RE: Minor Modification to the Soldier Canyon Mine - Partial Pillars Extraction in the 6th North, the 5th North and the 3rd North 5th East Sections

MINOR MODIFICATION TO
MINING PLAN APPROVED BY
BUREAU OF LAND MANAGEMENT

SOLDIER CREEK COAL COMPANY
SOLDIER CANYON MINE
ROCK CANYON SEAM
APPROVED MINE MAP

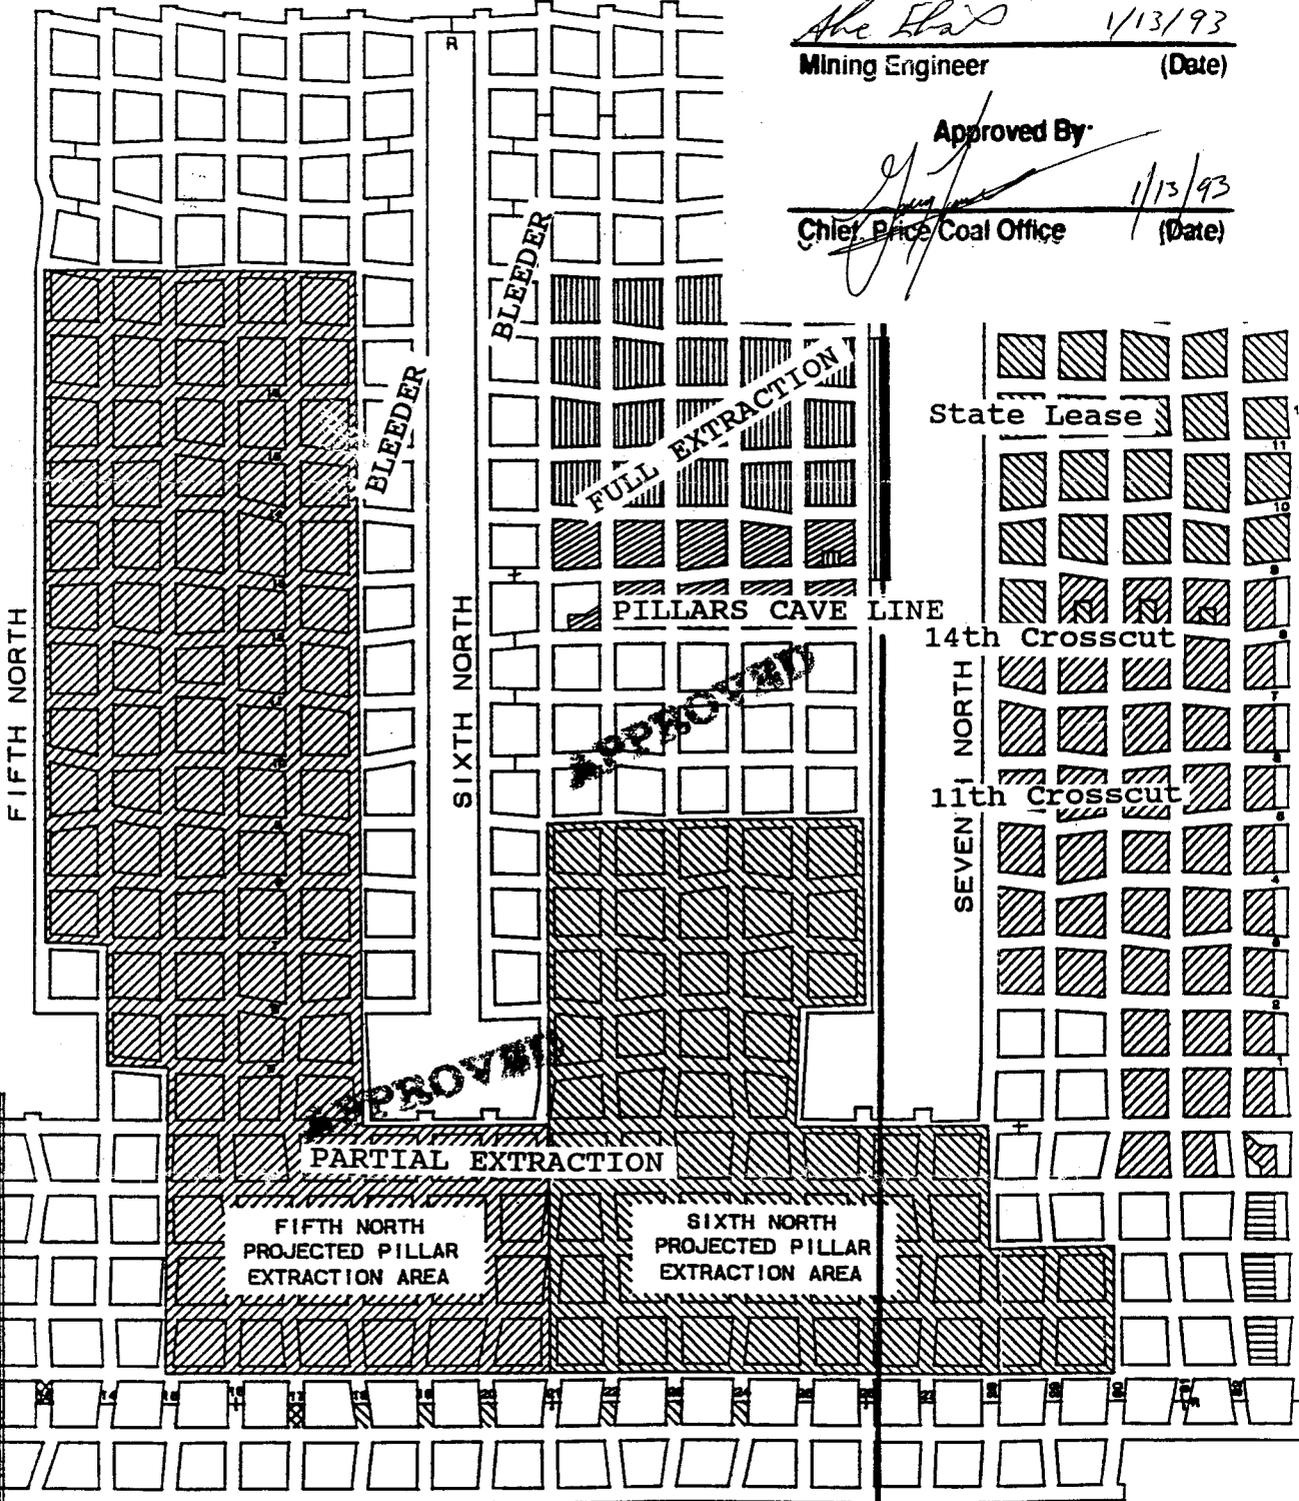
The approved plan for pillar retreat mining in the 6th North section was to fully extract pillar rows from north to south, with each row consisting of five pillars. One pillar in each row was left on the west side for a bleeder. Presently, the continuous miner is mining in the 5th pillar of pillar row #14 in by the 14th crosscut. The company is now proposing to abandon this row and the other three pillar rows to the south (rows #11 - #13). Starting with row #10, SCCC plans to implement a partial pillar extraction instead of the full pillar extraction originally planned (see enclosure). SCCC is expecting to utilize the partial extraction plan in the 6th North, the 5th North and the 3rd North 5th East sections.

According to SCCC, the modification is necessary due to the severe bouncing in the section which has deteriorated the pillars and caused roof failure. Shale and sandy shale material associated with roof fall has increased ash content in the overall mine production. It was jointly determined by the mine management and the Mine Safety and Health Administration (MSHA) inspector that further extraction in the present pillar line could not be continued safely. Large caves and weak roof conditions in the 6th North, the 5th North and the 3rd

A file search indicated that this section was developed on 80 x 80 foot centers. A 9 foot mining height is presently being mined under 1750 feet of overburden. The 6th North section was inspected by a BLM mining engineer on December 7, 1992. During the inspection, approximately 8 ft of the immediate roof in the #14 crosscut and pillars cave line were examined. The immediate roof was approximately 2 feet of coal overlain by 4 to 8 inches of sandyshale and 12 inches of soft shale. Approximately 5 to 6 feet of weak, laminated strata followed by a sandstone top were also observed behind the mined out pillars. The top coal was fracturing due to the bouncing activities in the section. The overlain shale and sandyshale were falling above the continuous miner which diluted the coal production.

On December 9, 1992, the 6th North section was reinspected. Floor heave, roof fractures, severe rib bursts and pillar failure were observed between #12 and #14 crosscuts. The #14 crosscut was experiencing a major roof fall, where plates were pulled out of the roof bolts due to extreme vertical pressures. Bouncing activities were expanding to approximately 200 to 300 feet behind the section's continuous miner.

Large caves were observed at the mouth of the 7th North section. The immediate roof strata in the caved material consisted of the same lamination observed at the 6th North section. Roof coal was also observed in the 6th North, the 5th North and the 3rd North 5th East sections. A discussion with SCCC representatives indicates that the top coal was left to protect crew members from roof falls and minimize ash dilution in the overall production. Independent calculations conducted by a BLM engineer indicate that a pillar size of 80 x 80 foot centers is marginal for 1500 to 1750 feet of cover.

The combination of a shale roof, the sandstone formation above the shale, and marginal pillar sizes have created an unsafe condition. The proposed plan of leaving three complete pillar rows and one partial row (16 pillars) should be an adequate barrier to support the overriding stresses in the 6th North section. Partial pillar extraction will redistribute the vertical and horizontal pressures as a precaution against further bounces. Also, the partial pillar extraction will delay the immediate roof from caving which will protect coal production from added dilution.

Under the present circumstances, Price Coal Office personnel agree with this proposal to abandon these pillars to reduce safety risks to the mining crew. The MSHA approved partial pillar extraction plan for the 6th North section is adequate and can be utilized for the 5th North and the 3rd North 5th East sections, in coordination with the authorized officer of the BLM. Full pillar extraction should be implemented when mining conditions allow.

BLM has determined that the mine plan change is in compliance with the Mineral Leasing Act of 1920, as amended, the regulations at 43 CFR 3480, the lease terms and stipulations, and will achieve maximum economic recovery of the Federal coal. Therefore, the BLM will allow the mine plan change. This confirms the verbal approval given to Soldier Creek Mine personnel on December 9, 1992. An estimated 120,000 tons of recoverable coal reserves are now deemed unrecoverable. A copy of the approved mine map is enclosed.
